Subject: REAR CONSOLE LID DOES NOT SLIDE SMOOTHLY	Bulletin No.: 09-024/20
	Last Issued: 07/22/2020

2020 CX-30

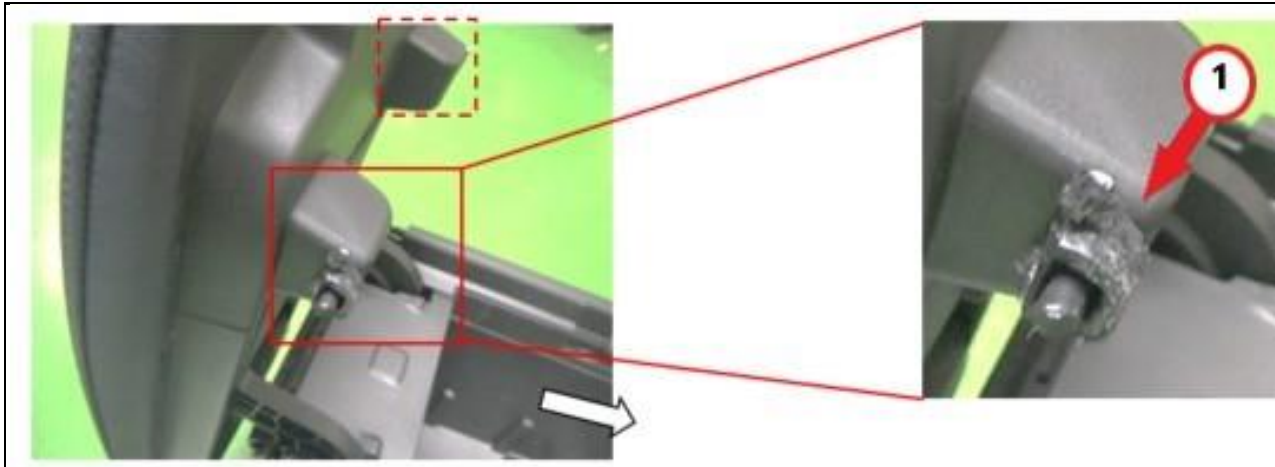
Some customers may complain that the rear console lid does not slide smoothly. This may be caused by improperly positioned felt pads attached to the rear console lid lock, which may have moved out of position after repetitive use. The exposed adhesive residue may stick to the rail and disrupt smooth sliding operation.

To eliminate this concern, the felt pad positions have been changed.

Felt A (5mm x 20mm)	Felt B (4.5mm x 43mm)

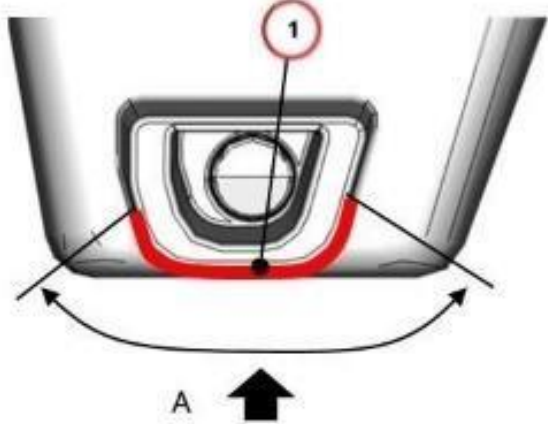
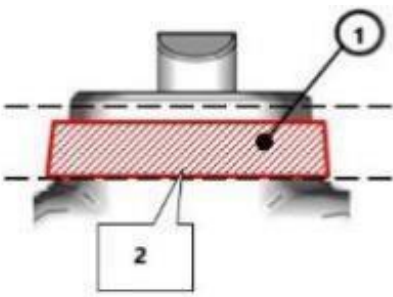
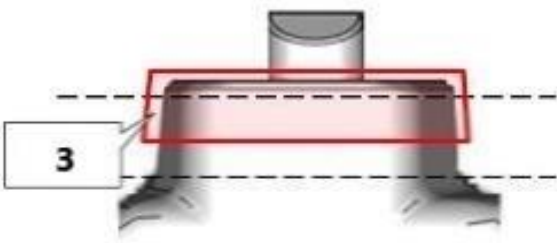
4. After removing all adhesive residue, clean the area using a clean cloth, then confirm the rails (upper and lower faces) are smooth.
5. Attach Felt A (1) as shown below.

<p>Side view of lid lock</p>	<p>Attach Felt A (1) to lid lock</p>
<p>Felt A Installation - Good</p>	<p>Felt A Installation - No Good</p>

<p>View from A</p>	
<p>2. The felt edge must attach the lid along the entire length.</p>	<p>3. The felt edge should not come out of the lid lock rim.</p>

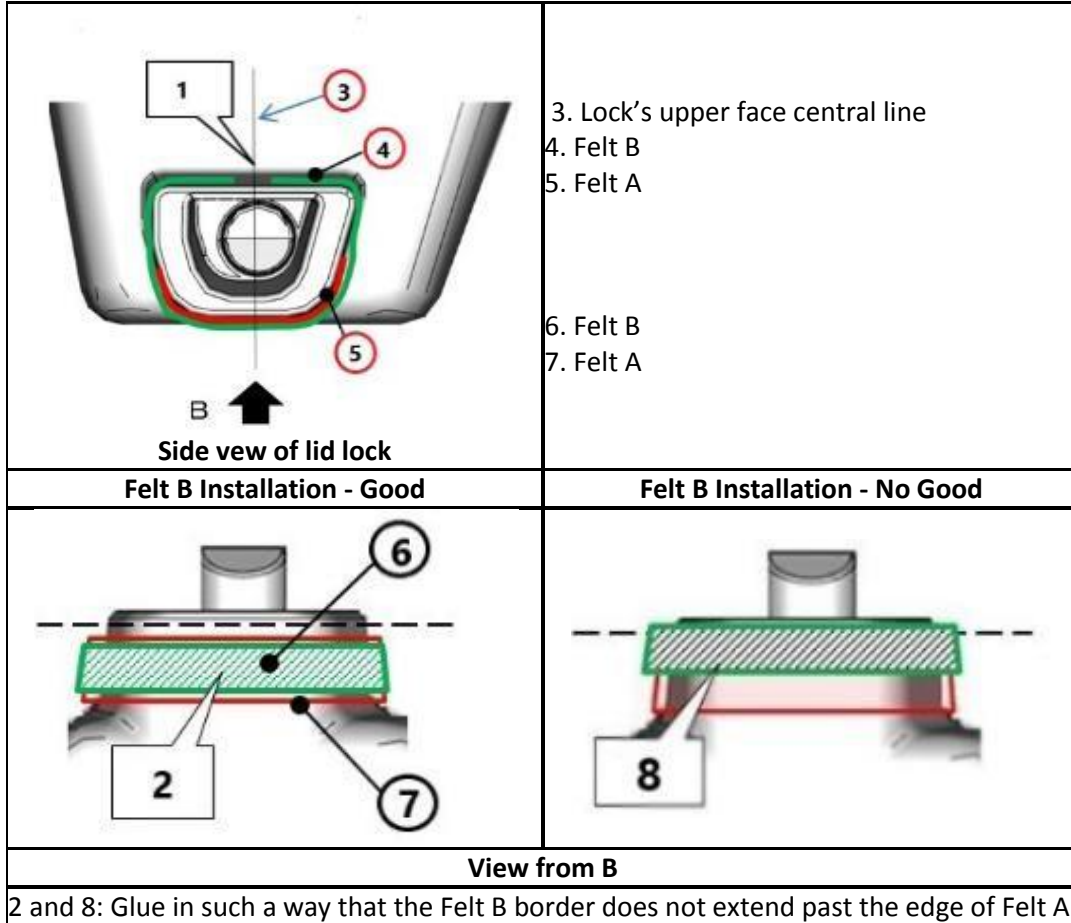
7. Attach Felt B as shown below.

NOTE: Felt B must be attached so that its two ends are located on the lock's upper face, symmetrical to the upper face central line (1), as shown below. Also, the ends of Felt B must not touch each other.

8. Glue Felt B onto Felt A (2) as shown below.
